Agenda Date: November 5, 2015
Item #5
Reconsideration Request

RE: Reconsideration Request
Horizon Hill Preliminary Plan No. 120120170 ("Plan")
MCPB Resolution No. 15-94

Horizon Hill: Preliminary Plan No. 120120170

A request for three lots for three one-family detached dwelling units as part of a re-subdivision on 6.35-acres in the RE-2 zone; located at 10616 Red Barn Lane on the southwest side of Red Barn Lane in the 2002 Potomac Subregion Master Plan.

Figure 5: The white arrow shows the proposed Access Point on Glen Mill Road (Point A in the map above). The driveway shown to the left of the arrow is the one the RRAC recommends sharing, if access from Red Barn Lane is not feasible.

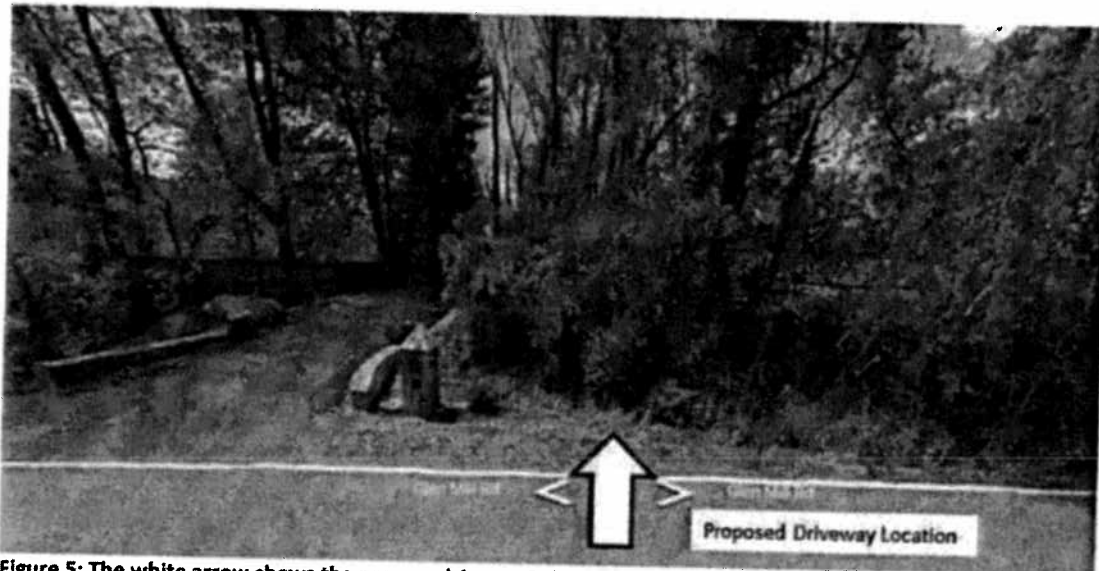
Staff does not support access for Lot 3 from Glen Mill Road. Staff believes there are several other options for the location of the driveway to Lot 3 that the Applicant has not evaluated and that should be analyzed. To date, the Applicant has been unwilling to submit information that would be required to analyze the impacts of a driveway for Lot 3, from Red Barn Lane.

Figure 9: Possible Driveway Alternatives

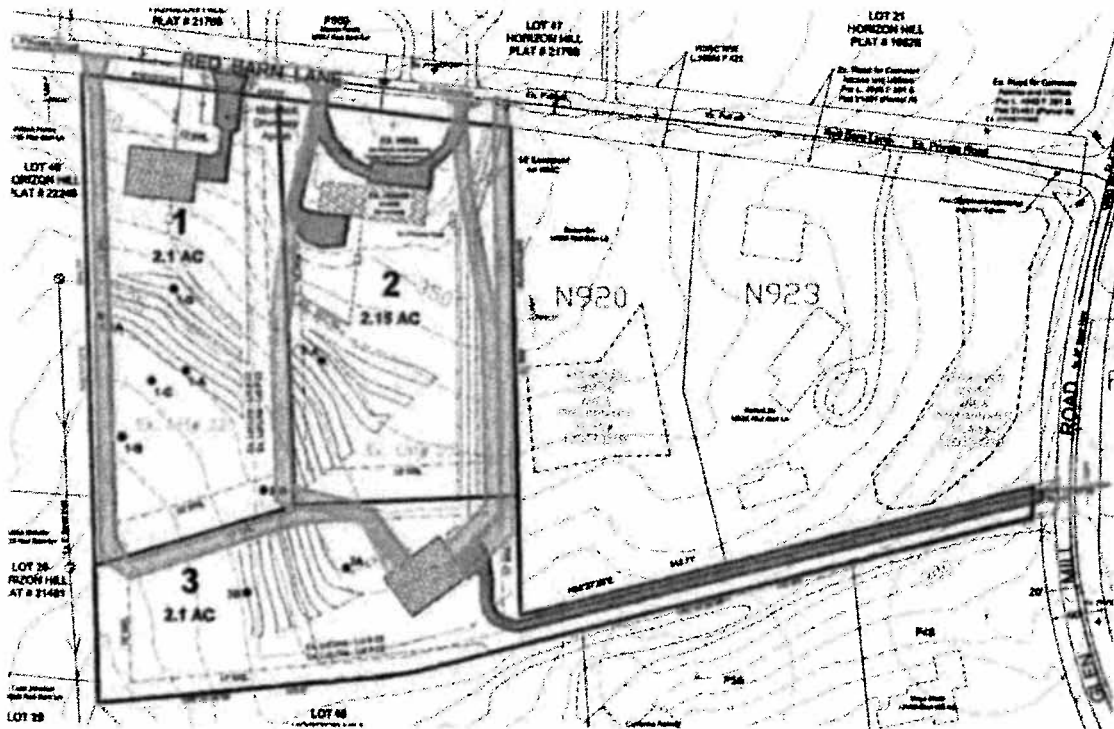
It is Staff's position that the Applicant can access Red Barn Lane and still achieve the proposed density being requested. The threshold of considering an access point on Glen Mill Road an Exceptional Rustic Road has not been met since there are viable alternatives which would still achieve a three lot subdivision (figure 9).

As described in the Master Plan section above, Staff finds that the proposed subdivision does not substantially conform to the 2002 Potomac Subregion Master Plan or the 1996 Rustic Roads Functional Master Plan due to the negative impact the proposed Lot 3 driveway location will have on the Exceptional Rustic Road. There are multiple driveway routes to Lot 3 from Red Barn Lane that will not impact the Exceptional Rustic Road. (Figure 9).

Figure 10 - Plat 18005: Driveway access denied

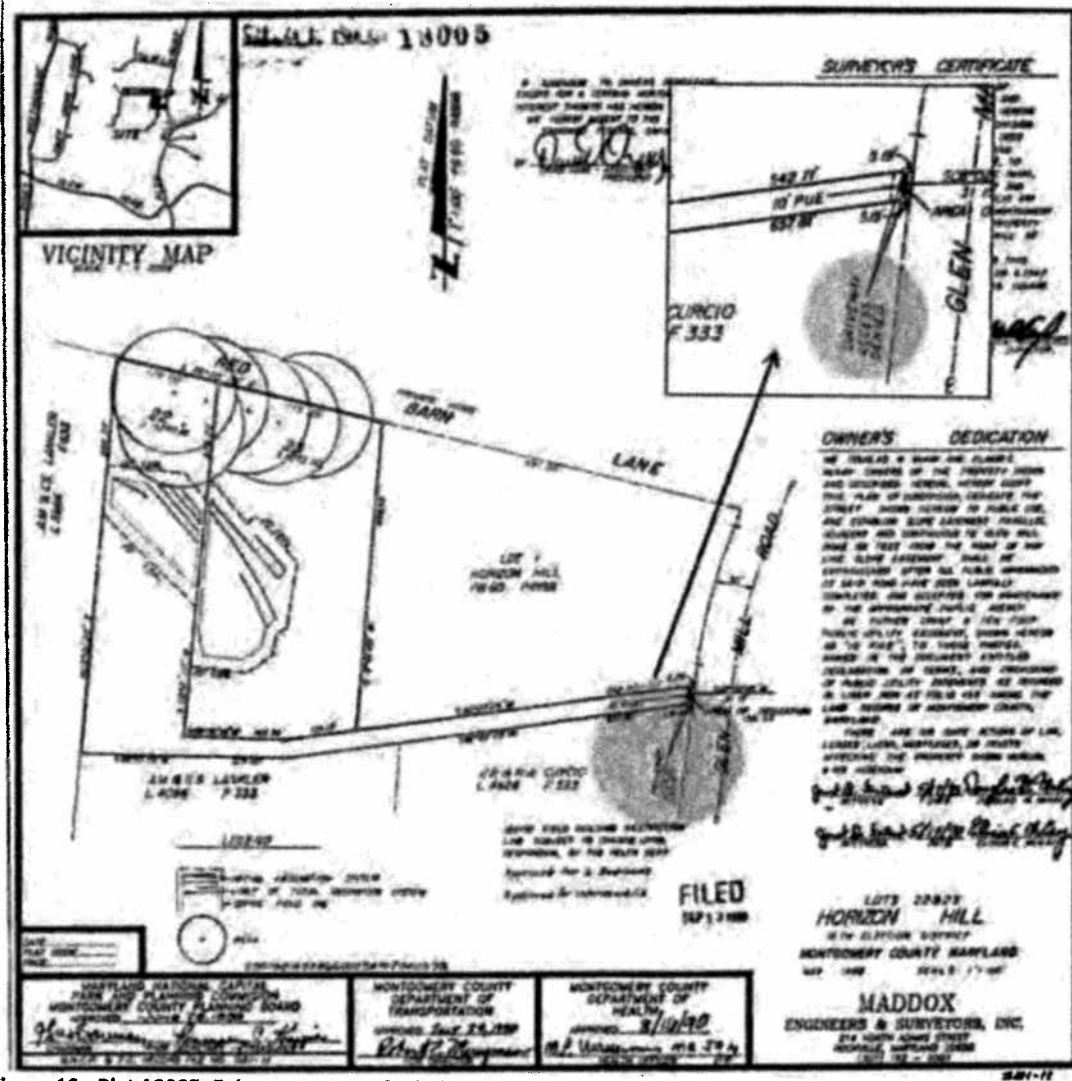
The Applicant proposes access to Lots 1 and 2 from Red Barn Lane, a private road, and Lot 3 would have access from Glen Mill Road, an exceptional rustic road. In 1990, (after the publication of the Proposal for a Rural/Rustic Roads Program and prior to adoption of the RRFMP) Plat 18005 depicted in Figure 9 was approved by the Planning Board stating "deny access to Glen Mill Road" from Lot 22, ostensibly to force the two lot subdivision to gain all access to Red Barn Lane. The note on the Record plat is a result

of Condition #3 of the Preliminary Plan Opinion #119892860 "No direct driveway access to Glen Mill Road" (Attachment H).

The previously approved Plat (#18005) currently restricts driveway access from Glen Mill Road. The construction of a new access point on Glen Mill Road will negatively impact the Exceptional Rustic Road. The RRAC, MCDOT, and Staff all recommend that the access for proposed Lot 3 be from Red Barn Lane and would only support access to Glen Mill Road if the Planning Board finds access to Glen Mill Road will not be a negative impact on an Exceptional Rustic Road. The Applicant has the ability to achieve the third lot with no impact to an Exceptional Rustic Road by accessing Red Barn Lane.

Figure 11: Proposed Variance Evaluated

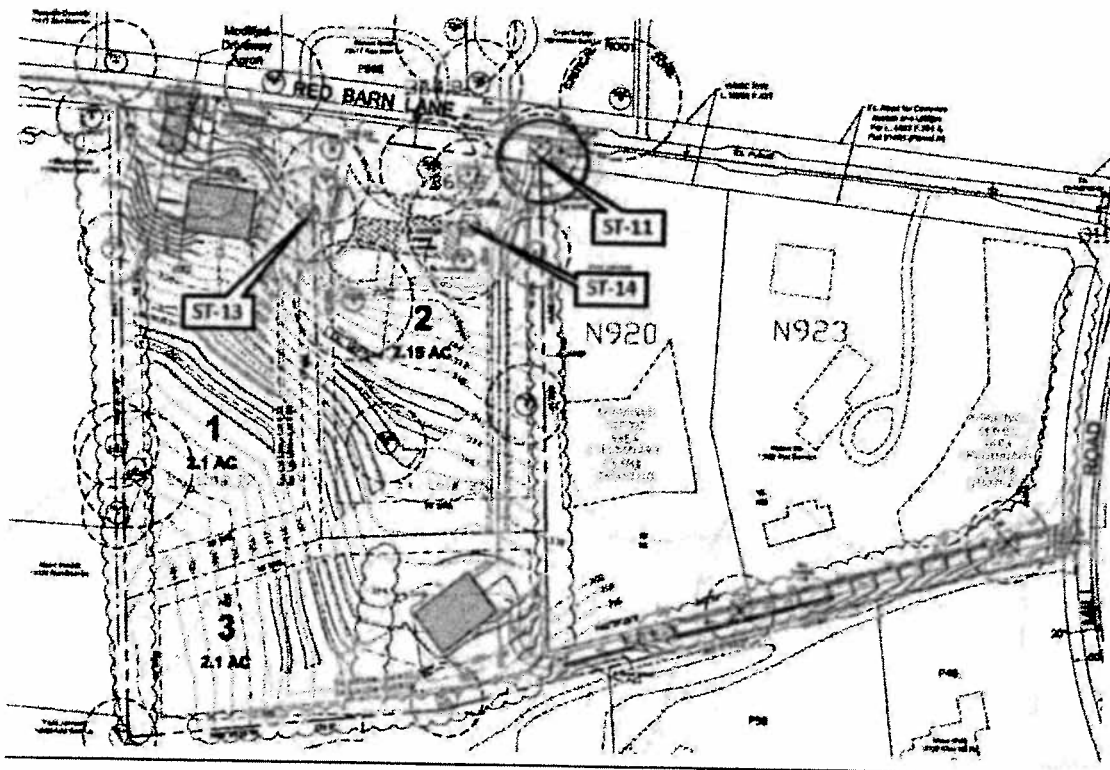
In October 2014, the Applicant made the initial variance request for the Subject Property. That request was revised several times but always included an analysis of impacts based on a driveway out to Glen Mill Road. The final version of the Variance was submitted on April 10, 2015 and requested impacts to two Protected Trees and the Removal of one Protected Tree.

Mitigation should be at a rate that approximates the form and function of the trees removed. Therefore, Staff is recommending that replacement occur at a ratio of approximately 1" caliper for every 4" DBH removed, using trees that are a minimum of 3" caliper size. For example, this means that for the 31" DBH of trees removed the Applicant should replace with 7.75 caliper inches of trees or three (3) 3" caliper size, native, canopy trees on the Property. While these trees will not be as large as the tree lost, they will provide some immediate canopy and ultimately replace the canopy lost by the removal of these trees.

Staff recommends that the variance could be granted with mitigation if the Planning Board chooses to approve the overall subdivision. The submitted FFCP meets all applicable requirements of the Chapter 22A of the County Code (Forest Conservation Law).
